GA-6HZR Generator

Receptacle Modification Instructions
Replaces 3-prong receptacle (P/N 06018111032)
with 4-prong receptacle (P/N 0601814010)

Figure 2. Receptacles Rear View Wiring

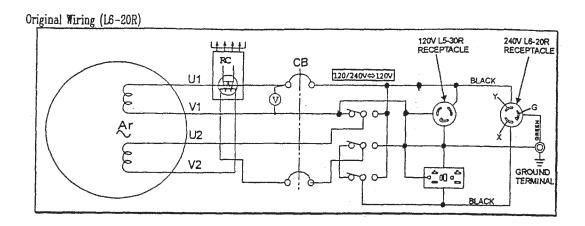
- Connect a #10 AWG WHITE wire (NEUTRAL) from terminal X of the adjacent L5-30R receptacle to terminal W on the new L14-20R receptacle. Use Figures 2 and 3 to aid you in adding this wire.
- 8. Place the control box panel back onto the generator and reinstall the four bolts (Figure 1) that secure the control box panel.
